RESPONSE TO ENVIRONMENT AGENCY OBJECTION

Proposal: Conversion and Subdivision of Warwick Mill to 135 No. Apartments (Use Class C3) and Flexible Commercial Space (Use Class E) Including Works of Demolition and Formation of Interior Atria, Parking at Lower Ground-Floor Level and Demolition of London House and Erection of Building to Provide 146 No. Apartments (Use Class C3) (281 Total), and Flexible Commercial Space (Use Class E) Formation of External Car Parking, Public Realm, Landscaping, Alteration to Existing Vehicular Access and Creation of Additional Vehicular Access to Oldham Road (A669) and Associated Internal and External Additions and Alterations. Planning Application 23/00795/FUL.

Figure 1: Flood depths within building footprints (baseline and proposed) 100 year +35% floodplain

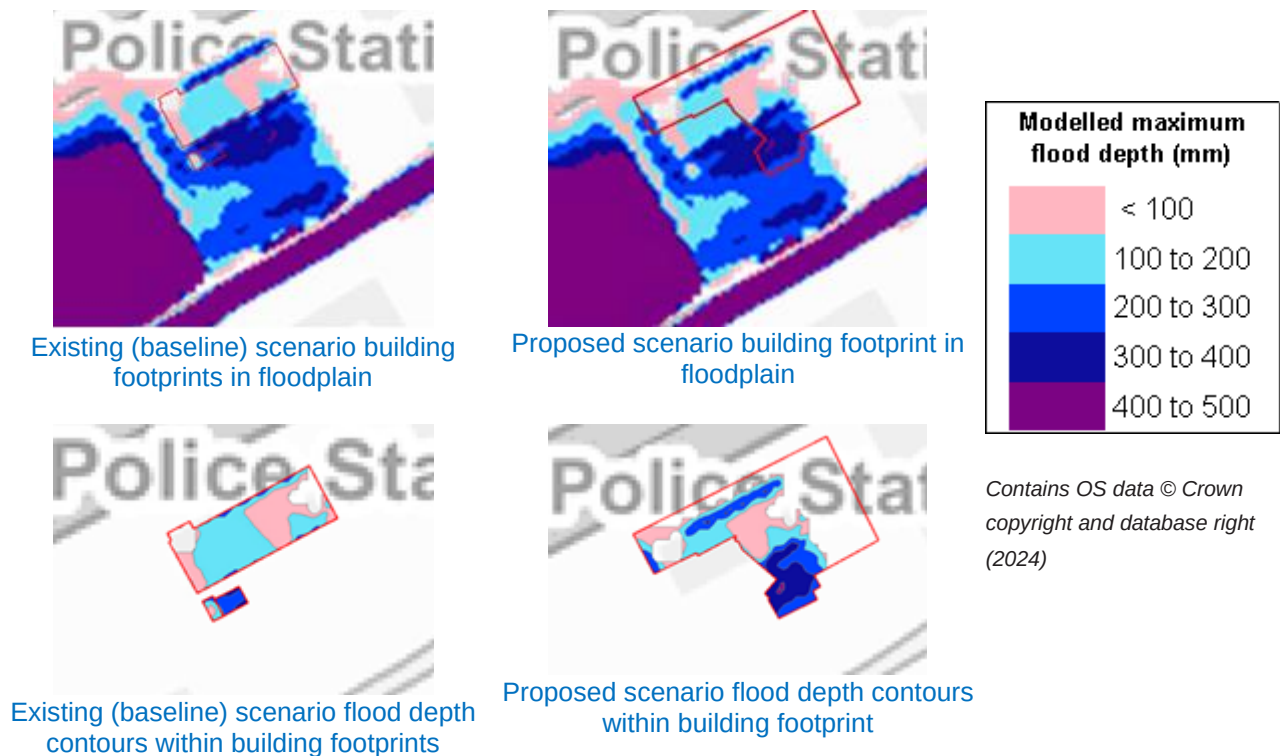
Letter received on 10th June 2024: *Regarding the issue of the noted increases in flood risk elsewhere when comparing the baseline and post-development flood outlines - the current development proposal offers no compensatory volumetric loss to offset the impact from the Loom development within the floodplain. While we agree the mechanisms are complex, where loss or obstruction of the floodplain occurs resulting in demonstrated adverse impacts elsewhere - development proposals should be sympathetic and include valid efforts to incorporate compensation and suitable mitigation to ensure compliance with the NPPF and PPG paragraph 049.*

Conversation with Planning Officer: *Regarding the volumetric loss of flood plain, which although shown as minimal within the modelling, would still be contrary to national policy and EA guidance. The EA are looking for it to be demonstrated if off-site impacts are tangible in the first place, and if the volumetric loss of the flood plain can be compensated for, whether this be through manipulation of land levels on or off-site to provide no net loss of flood-water storage.*

[The opportunity to incorporate floodplain compensation on site has been explored. The design event used is the 1 in 100 year +35% CC scenario. Floodplain storage can provided up to this level as presented below.](#)

[In the existing baseline scenario, the footprint of the London House building and another smaller building on this part of the site are within the floodplain extent. In the proposed development scenario these buildings are demolished and replaced by the proposed Loom building - the footprint of which is also in the floodplain extent. This is shown in Figure 1.](#)

The top water level during the 1 in 100-year plus 35% climate change allowance is 78.98 m AOD. The depth results have been contoured into 100 mm slices and the area impacted (and thus volume i.e. area x 100 mm) at each slice has been calculated. This has been undertaken for both baseline and proposed footprints allowing the difference (floodplain gain/loss) on a slice by slice basis. This is shown in Table 1 below.

It can be seen that Slice A and E have very negligible volumes of floodplain loss (less than 2m²) and at Slice D there is an 'automatic' floodplain gain through implementing the proposed demolition and relocation of the building(s). Therefore the focus has been on providing the required volume at Slices B and C which are the slices witnessing more substantial floodplain loss.

Figure 2: Area of proposed lowering adjacent to floodplain. Floodplain is shaded turquoise, existing site levels re shown as black labels.

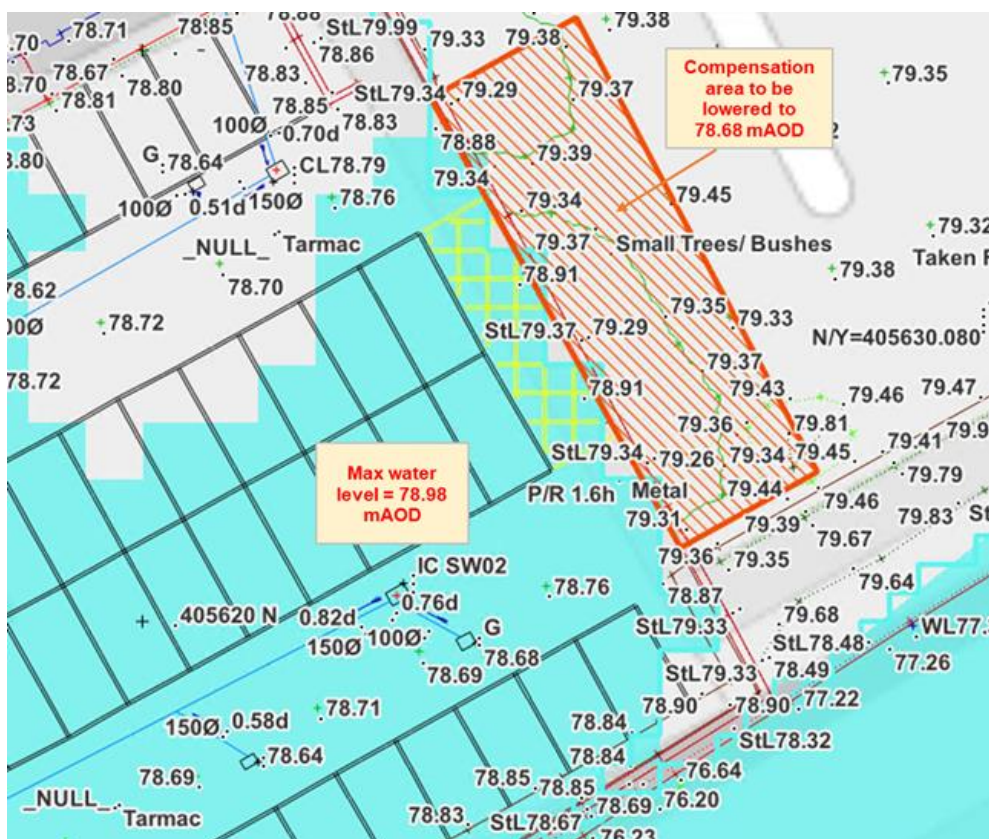
Letter received on 10th June 2024: Regarding the ground floor car park being constructed above the floodplain on stilts, we can confirm that we do not consider this to be a suitable method of developing in a flood risk area, but rather mitigation of risk by design. The use of stilts reduces the impact on the development but does not guarantee that the floodplain will be retained in the same way as a designated compensation scheme (which is a form of risk substitution).

Conversation with Planning Officer: The EA are generally seeking to ensure that the new building provides an appropriate treatment in the flood plain, stilted development is generally viewed as inappropriate by the EA

GMA architects have produced a drawing showing the proposed development flood risk and mitigation area. This is provided as Annex A.

The above demonstrates that a feasible solution can be implemented on site to provide the required compensatory flood storage.

ANNEX A: Proposed development flood risk and mitigation area drawing

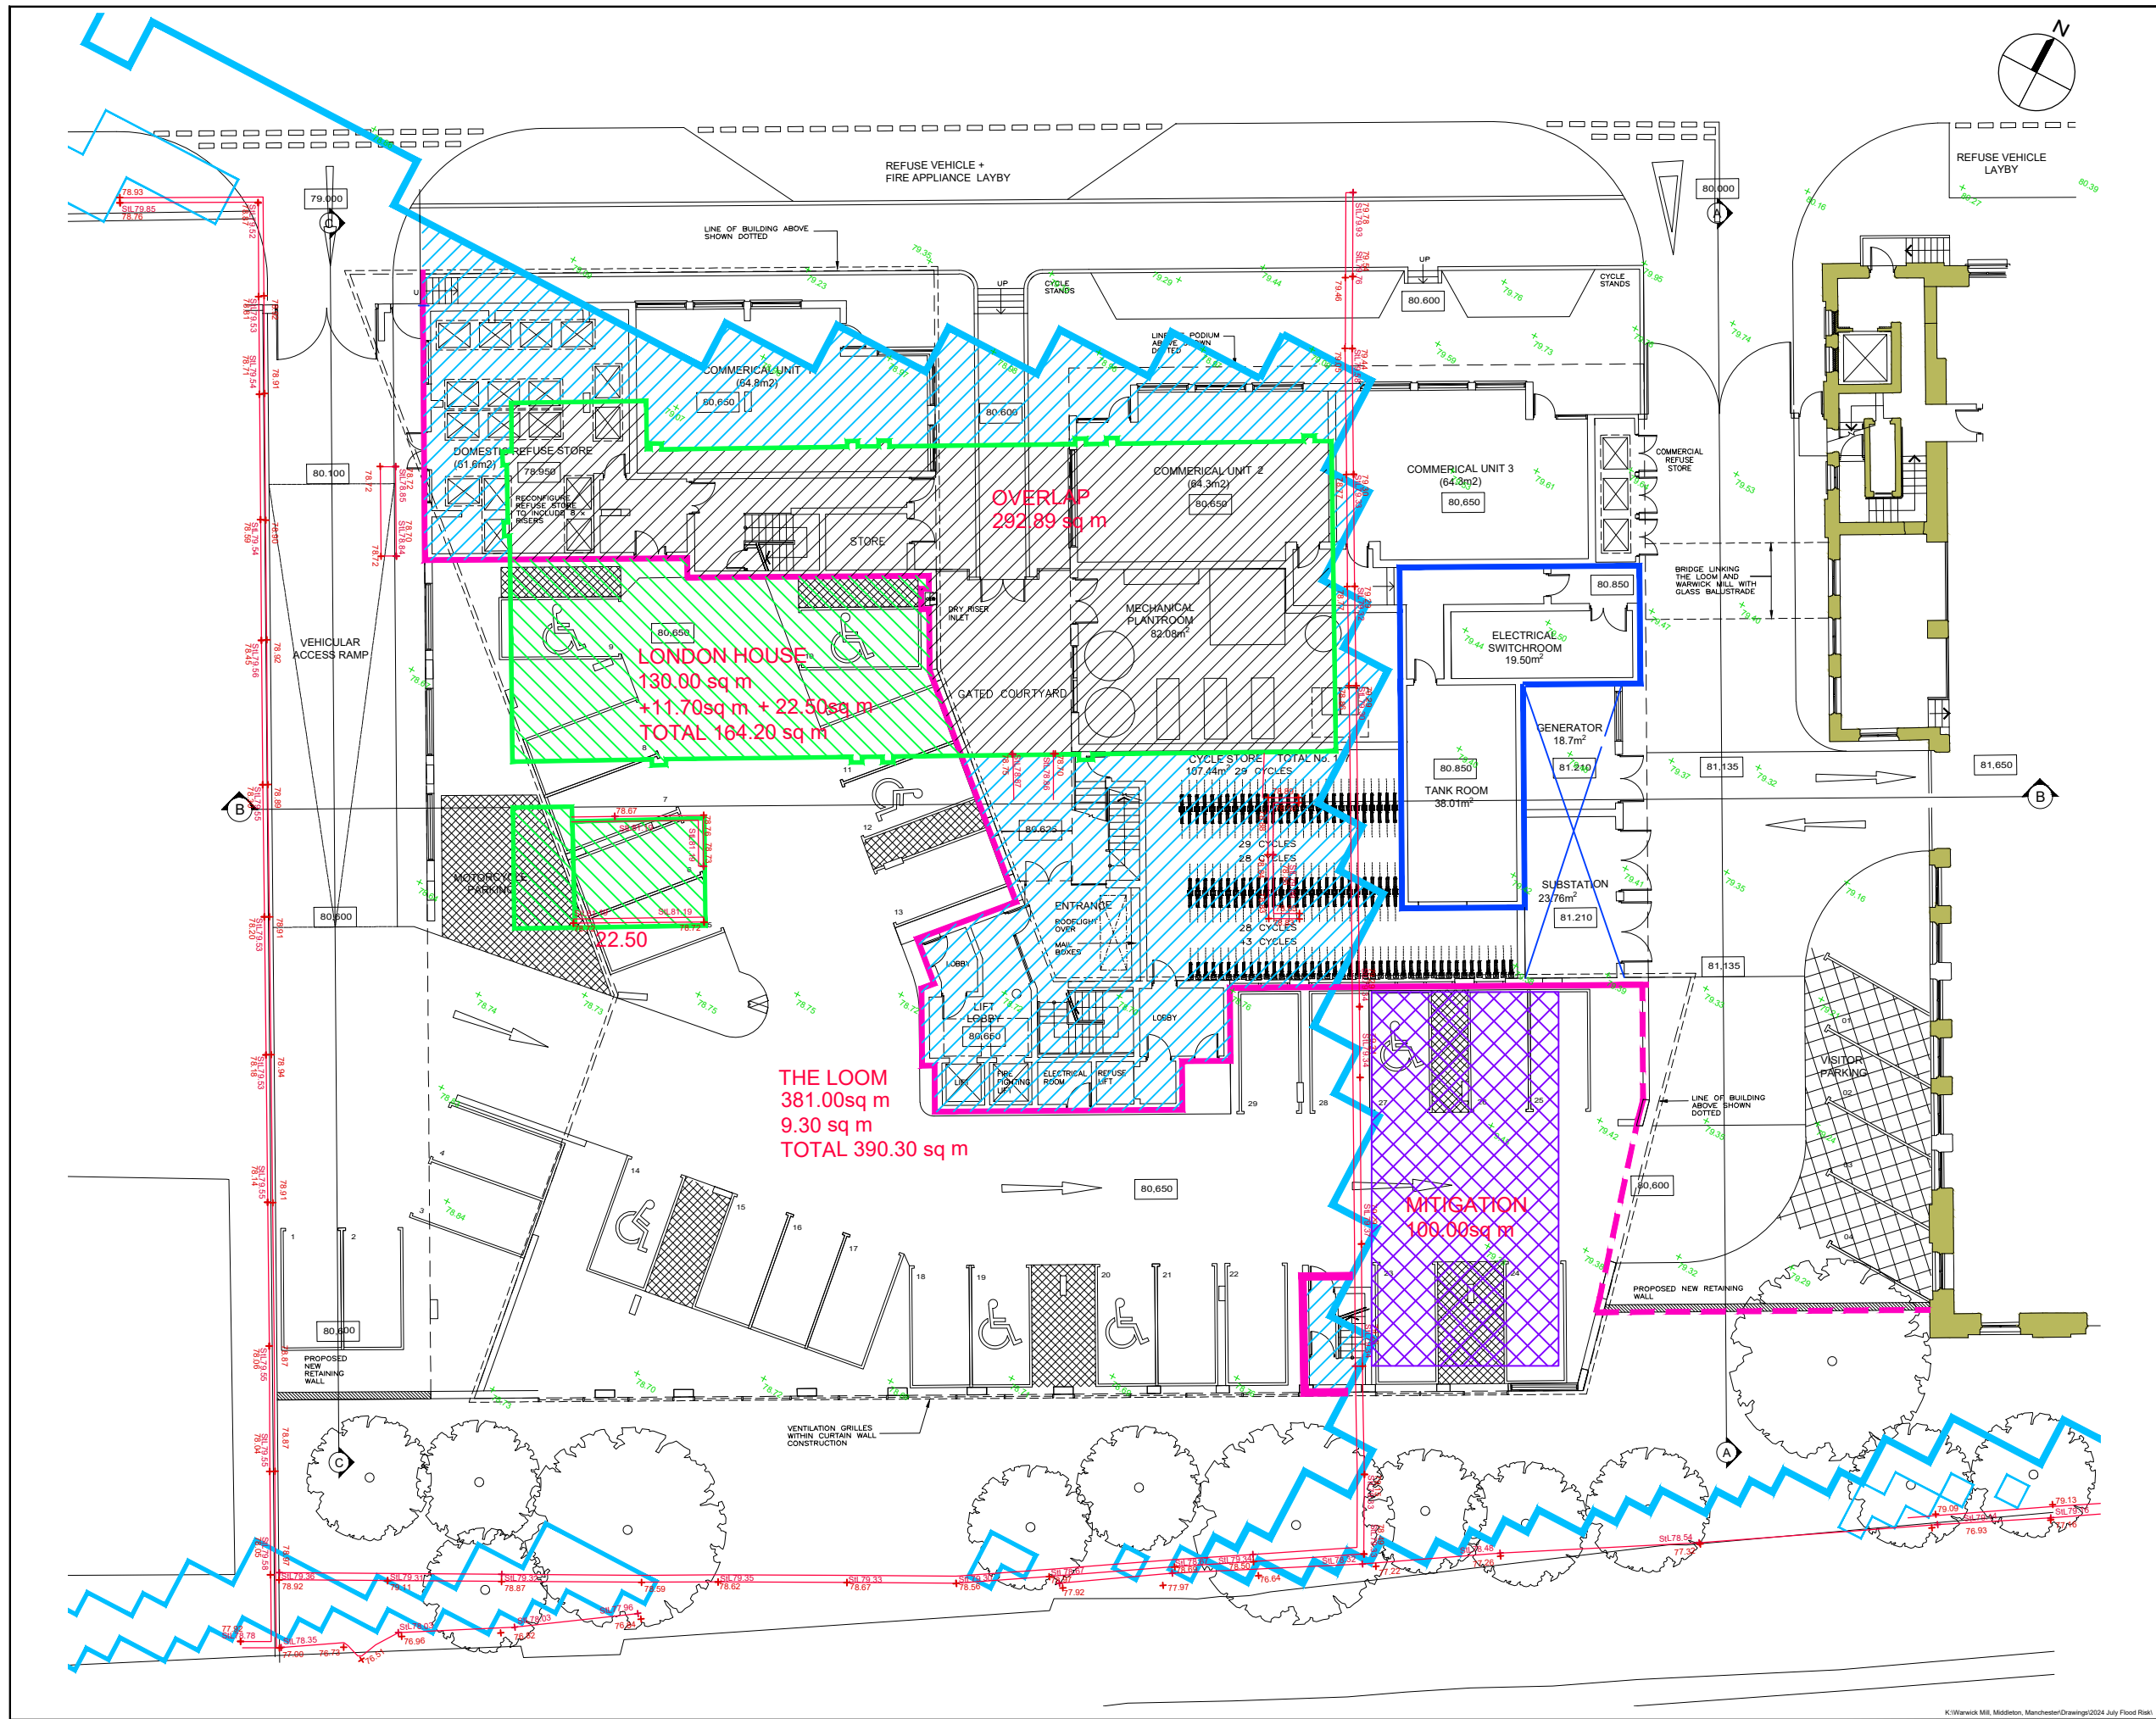
Letter received on 10th June 2024: Regarding the ground floor car park being constructed above the floodplain on stilts, we can confirm that we do not consider this to be a suitable method of developing in a flood risk area, but rather mitigation of risk by design. The use of stilts reduces the impact on the development but does not guarantee that the floodplain will be retained in the same way as a designated compensation scheme (which is a form of risk substitution).

Conversation with Planning Officer: The EA are generally seeking to ensure that the new building provides an appropriate treatment in the flood plain, stilted development is generally viewed as inappropriate by the EA

who would be looking for the developer to demonstrate that alternatives have first been considered and discounted.

GMA architects have produced a drawing showing the proposed development flood risk and mitigation area. This is provided as Annex A.
